SUBMITTAL OF HANFORD FACILITY RESOURCE CONSERVATION AND RECOVERY ACT (RCRA) PERMIT MODIFICATION NOTIFICATION FORM 24590-LAW-PCN-ENV-06-004

Hanford Facility RCRA Permit Modification Notification
Form 24590-LAW-PCN-ENV-06-004

Hanford Facility RCRA Permit Modification Notification Form
Part III, Operating Unit 10
Waste Treatment and Immobilization Plant

The purpose of this modification is to update the general arrangement drawings currently located in Appendix 9.4 of the Dangerous Waste Permit (DWP). As discussed in "Proposed Transition Period for Implementing Revised Process for Permit Incorporation of Design Documents at the Waste Treatment and Immobilization Plant (WTP)" (CCN 141838), the following source General Arrangement drawings are submitted to replace the permit General Arrangement drawings currently in Appendix 9.4:

PLAN AT EL (-)21'-0"

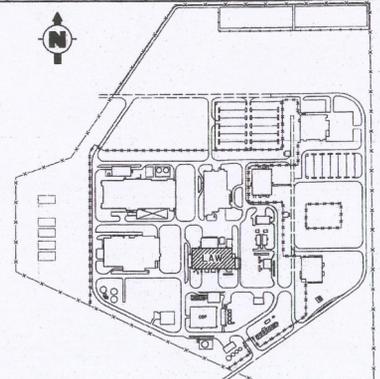
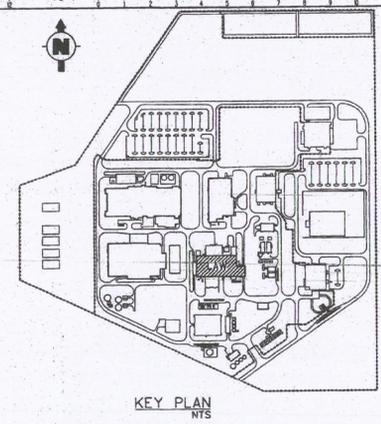
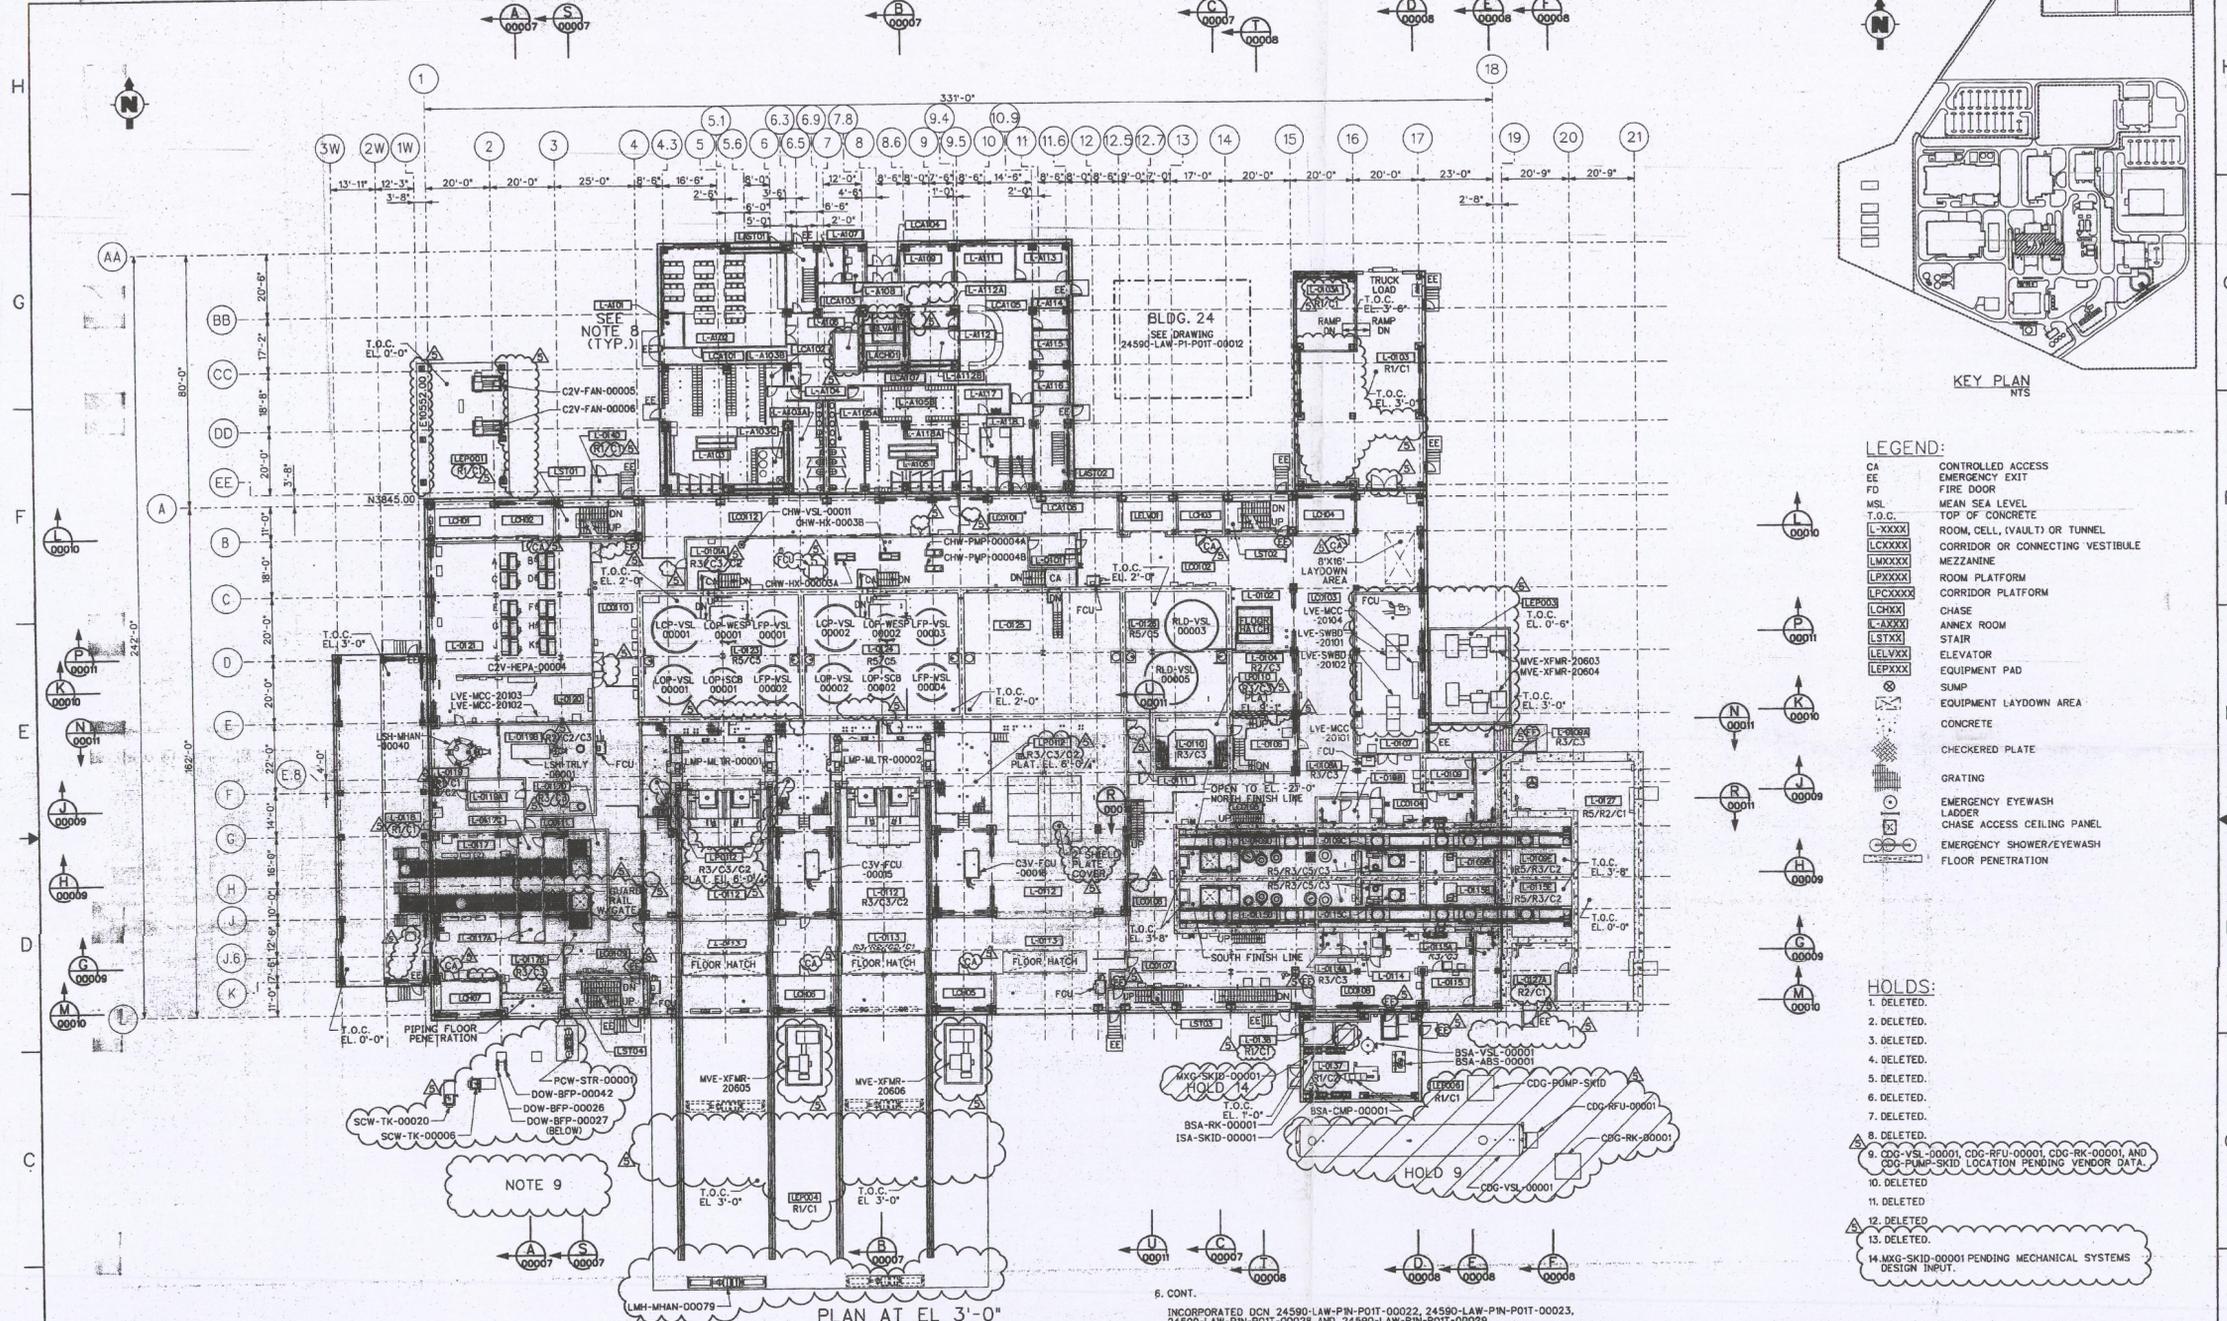
- LAW Vitrification Building General Arrangement Plan at El. (-) 21'-0" (24590-LAW-P1-P01T-00001)
 - Reconfiguration of doorways to rooms L-B012 and L-B014 to allow sufficient access for all required maintenance activities
 - Elimination of one LAW melter and equipment associated with the 2 + 2 melter configuration
 - Removed sumps associated with third LAW melter pour cave (dry area)
 - Removed two facility transformers in accordance with Electrical Design Criteria and Guide (24590-WTP-DC-E-01-001) (25% excess capacity requirement is still met with reduced number of transformers)
 - Approved Drawing Change Notices impacting this drawing: 24590-LAW-P1N-P01T-00025 and -00027

- Approved Field Changes impacting this drawing:
 - 24590-WTP-FC-E-05-0034: Modified conduit spacing to eliminate potential air pockets in poured concrete

- 24590-WTP-FC-E-06-0046: Designed new conduit support
 - 24590-WTP-FC-E-06-0096: Relocate enclosure PTJ-ENCL-00010 to prevent interference with pipe support

- 24590-WTP-FC-E-06-0106: Moved UPE-PNL-20072 to the west wall of room L-B09 to eliminate piping interference and rename panel LVE-PNL-20070 to UPE-PNL-20072

- Removed room schedule
- LAW Vitrification Building General Arrangement Plan at El. 3'-0" (24590-LAW-P1-P01T-00002)
 - Revised melter assembly pad - added R1/C1 designation

**LAW VITRIFICATION BUILDING
 GENERAL ARRANGEMENT
 PLAN AT EL. 3'-0"**

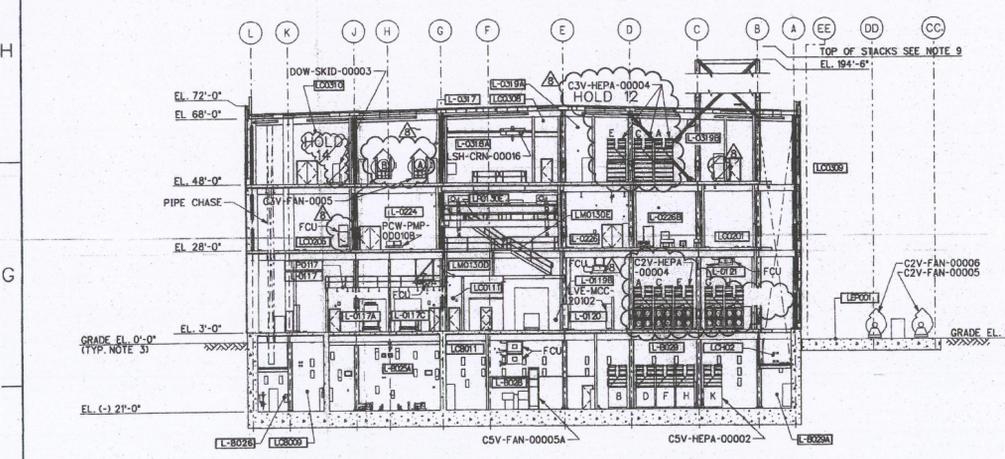
- Added callout for 2-inch plate cover over third melter bay (room L-0112)
 - Added callout for LMH-MHAN-00079 and SCW-TK-00006
 - Note 4 appended to indicate 24590-LAW-P1-P23T-01003 for equipment identification numbers

- Revised configuration of MVE-XFMR-20603, MVE-XFMR-20604, MVE-XFMR-20605 and MVE-XFMR-20606, LVE-MCC-20104, LVE-SWDB-20101 and LVE-SWDB-20102 (release of hold 13)

- Added C3V-FCU-00038 to room L-0101A
- LAW Vitrification Building General Arrangement Plan at El. 22'-0" (24590-LAW-P1-P01T-00003)
 - Reconfigured position of LOP-PMP-0003A/B and LOP-PMP-0006A/B

SECTION A
P1-P01T-00001 THRU 00006

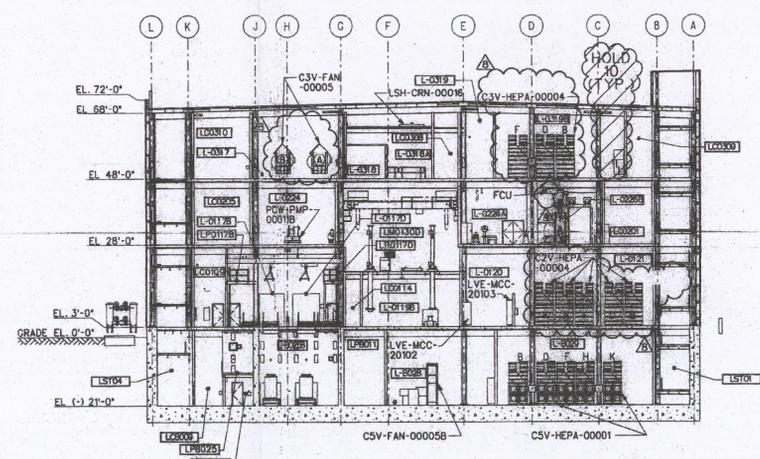
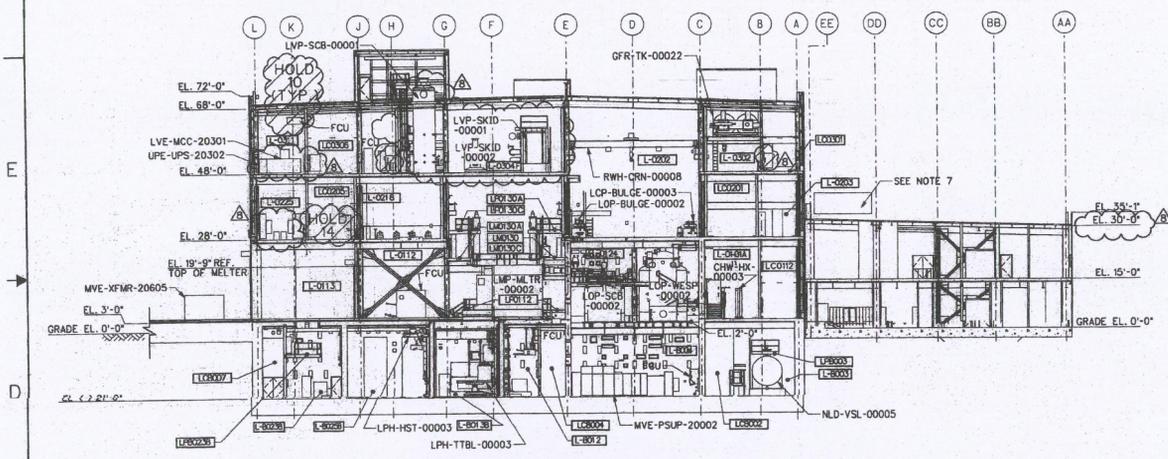
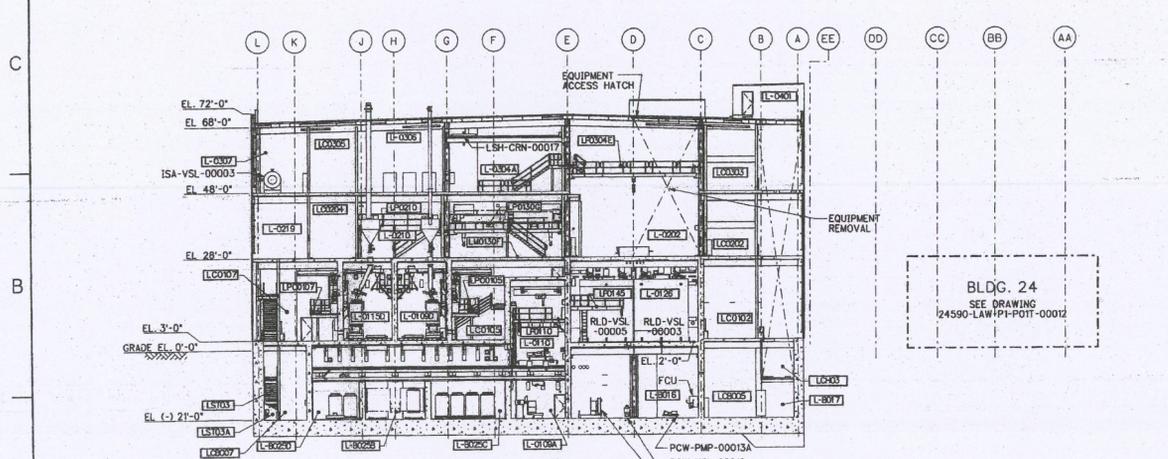
- LAW Vitrification Building General Arrangement Section A-A, B-B, C-C and S-S (24590-LAW-P1-P01T-00007)
 - Updated LVP-SKID-00001/2 and LVP-SCB-00001 configuration (release of hold 5, Section B)

- Updated C2V-HEPA-00004 and C3V-HEPA-00004 configuration (release of hold 12, Sections A and S)
 - Updated C3V-FAN-00005 configuration (release of hold 13, Sections A and S)

- Relocated and modified electrical equipment in rooms L-0311 and L-0225 (Section B)
- LAW Vitrification Building General Arrangement Section D-D, E-E, F-F and T-T (24590-LAW-P1-P01T-00008)

**LAW VITRIFICATION BUILDING
 GENERAL ARRANGEMENT
 SECTION G-G, H-H AND J-J**

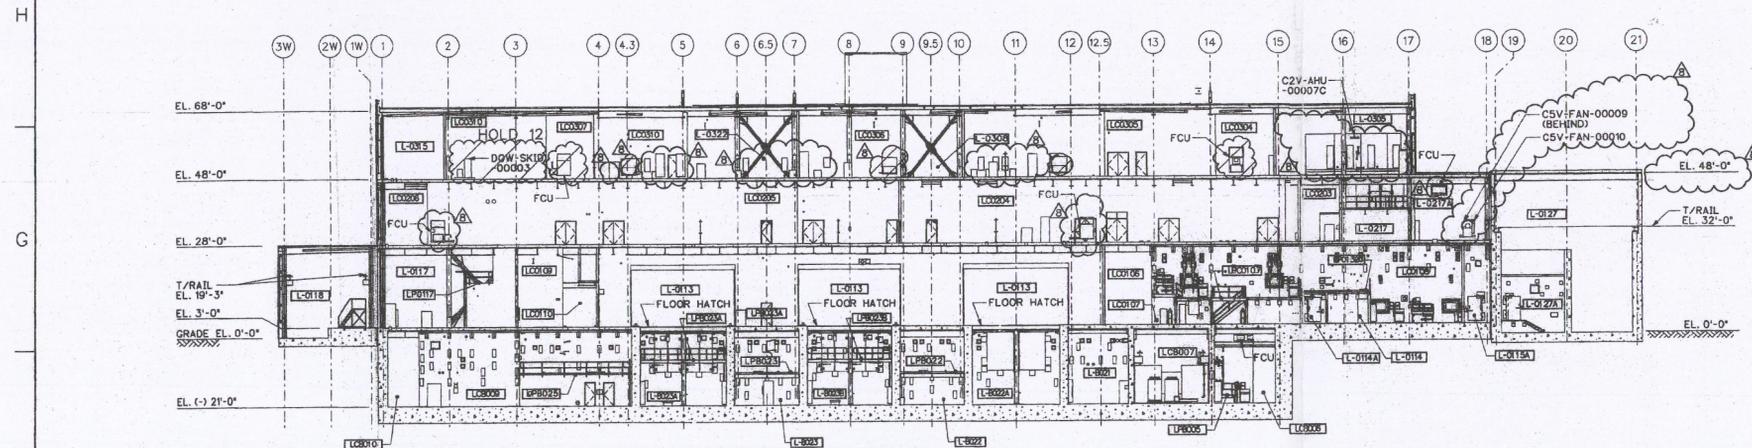
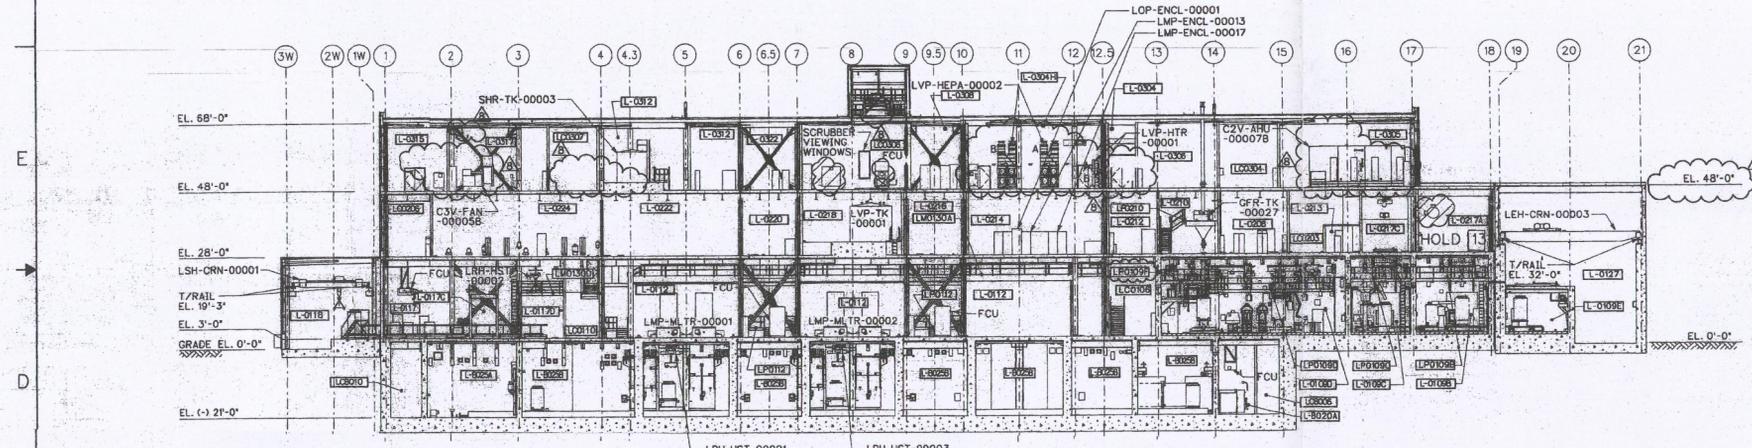
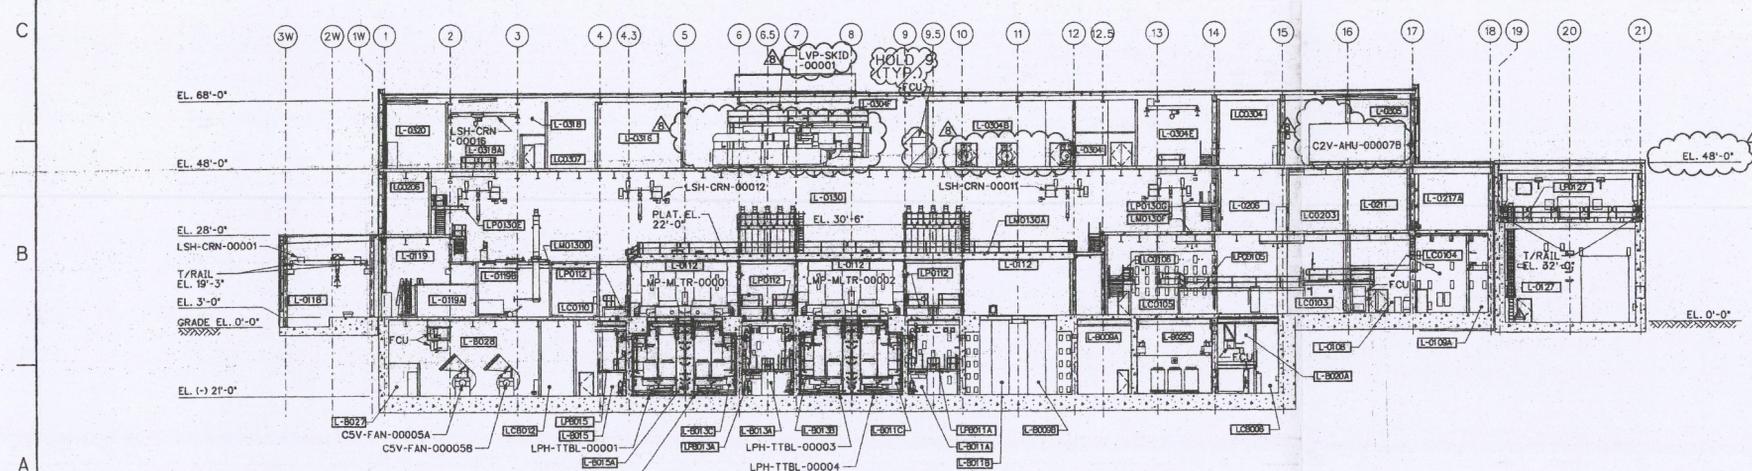
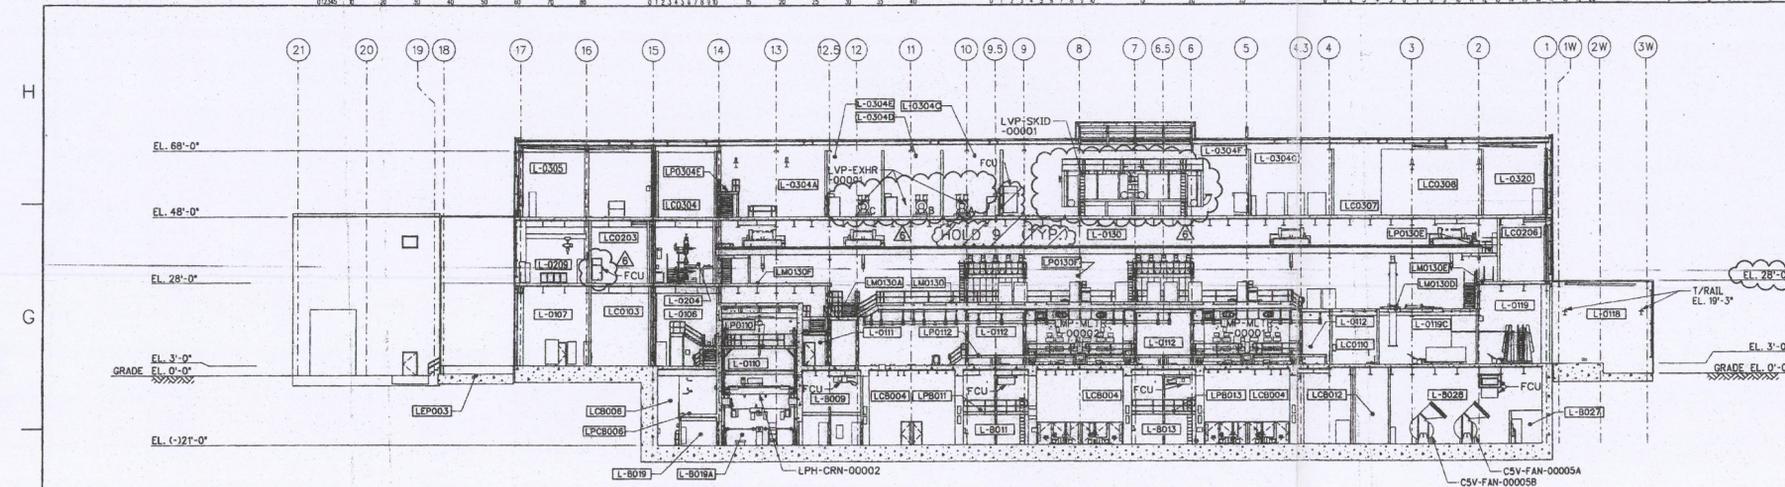
- LAW Vitrification Building General Arrangement Section G-G, H-H, and J-J (24590-LAW-P1-P01T-00009)
 - Updated configuration of LVP-SKID-00001, LOP-ENCL-00001, LMP-ENCL-00013/17 (release of hold 6)

- Updated configuration of NaOH pump (associated with SHR-TK-00003) (release of hold 10)
 - Configuration of C5V-FAN-0009/10 and fan coil unit shown (release of hold 13)

- LVP-HEPA-00002A/B equipment configuration shown in Section G
- LAW Vitrification Building General Arrangement Section K-K, L-L, and M-M (24590-LAW-P1-P01T-00010)

SECTION N
P1-P01T-00001 THRU 00006

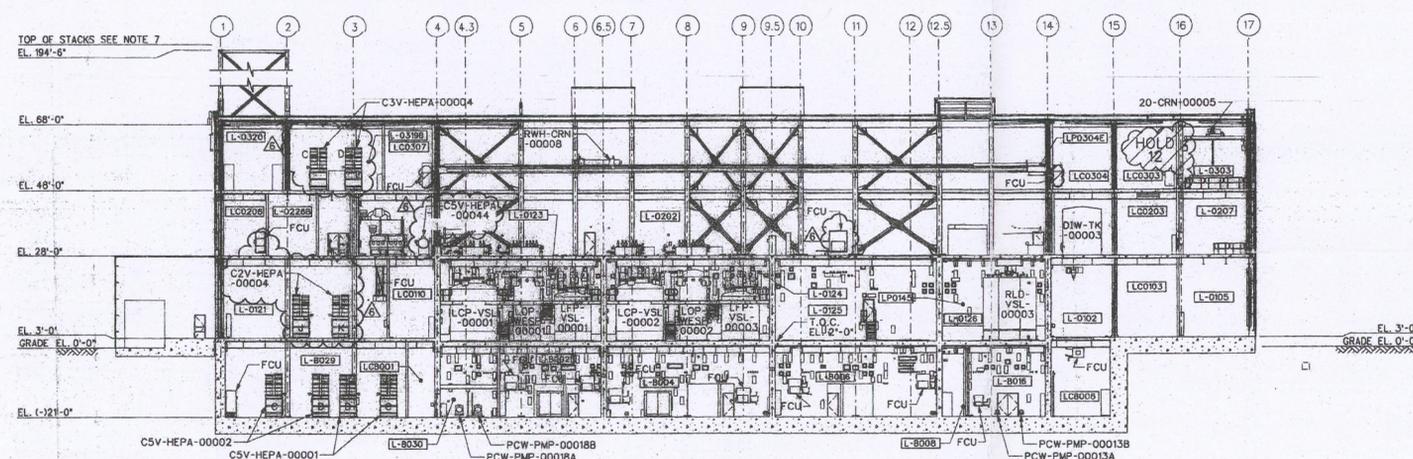
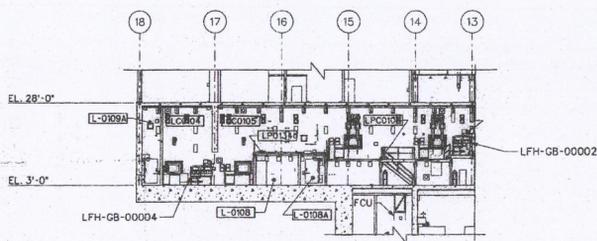
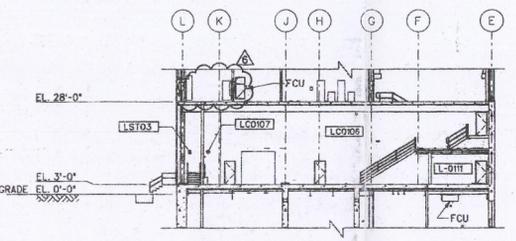
- LAW Vitrification Building General Arrangement Section N-N, P-P, R-R and U-U (24590-LAW-P1-P01T-00011)
 - Update of LVP-EXHR-00001A/B/C and LVP-SKID-00001 (release of hold 8)

- Release of hold 10 on C2V-HEPA-00004 and C3V-HEPA-00004
 - Added hold 12
